Generation Deactivation Quick Fix Manual 14D Compliance Changes

Manager, System Planning Modeling & Support
Markets & Reliability Committee

July 27, 2022

Manual 14-D, Generator Operational Requirements Revisions

M14D, Generation Deactivation Process Flow

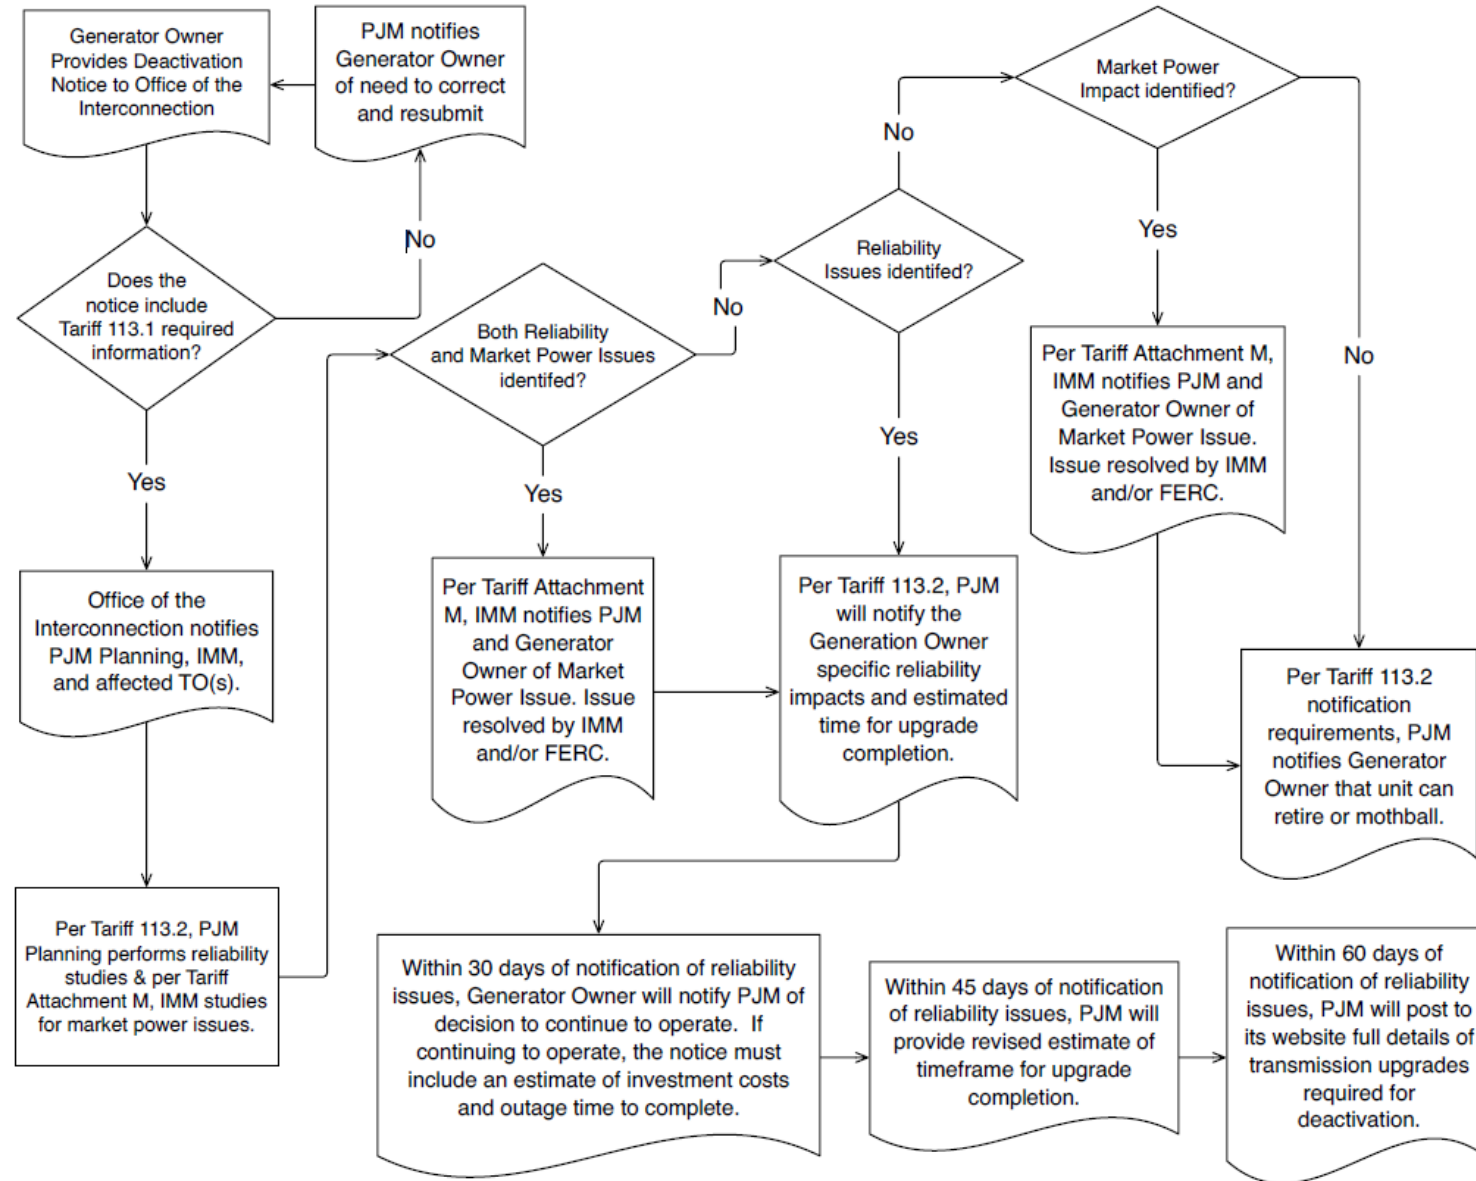
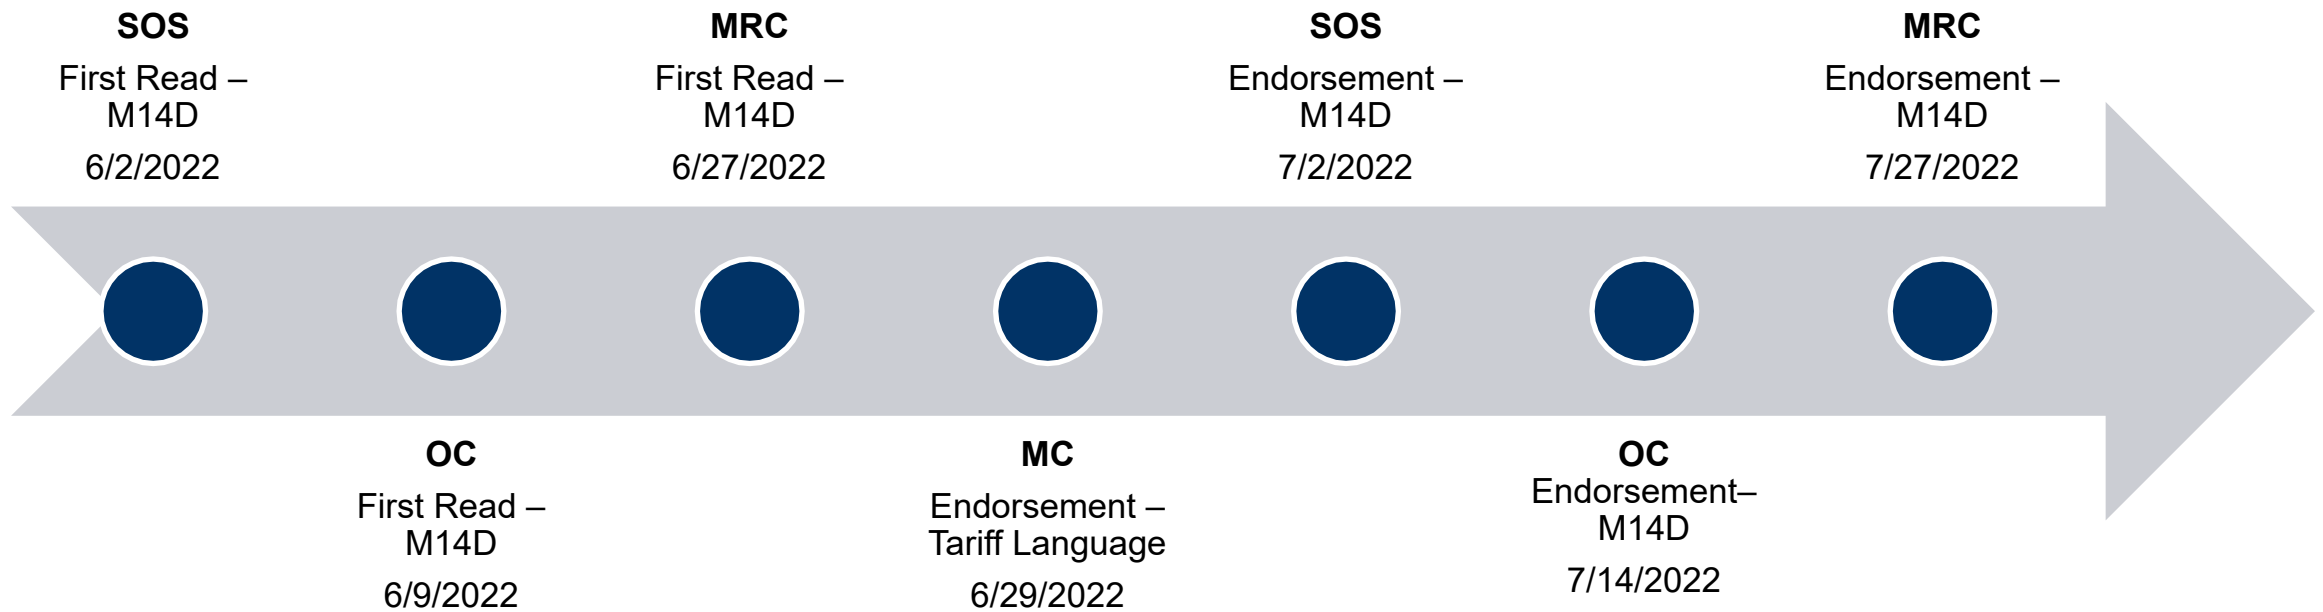
- Consistent with the schedule set forth in this section 9.1.3, PJM will notify the Generation Owner, or its designated agent, ~~within 30 days of the deactivation request~~ if a reliability issue has been identified. This notice will include the specific reliability impact resulting from the proposed deactivation of the unit, as well as an initial estimate of the period of time it will take to complete the Transmission upgrades necessary to alleviate reliability impact.

- Within ~~60~~ 30 days of ~~Deactivation~~ PJM's notification of reliability issues ~~Notice,~~ Generation Owner, or designated agent, will notify PJM of decision to continue to operate. If continuing to operate, the notice must include an estimate of investment costs and outage time to complete.

- Within ~~75~~ 45 days of PJM's notification of reliability issues ~~the original deactivation request,~~ PJM will provide a revised ~~n updated~~ estimate of the ~~period~~ timeframe for completion of ~~time it will take to complete the T~~ transmission upgrades necessary to alleviate reliability impact.

- Within ~~90~~ 60 days of PJM's notification of reliability issues ~~initial deactivation request,~~ PJM will inform the Generation Owner, or designated agent, and post on its web site full details of the transmission upgrades that will be required in order to allow the unit to deactivate.
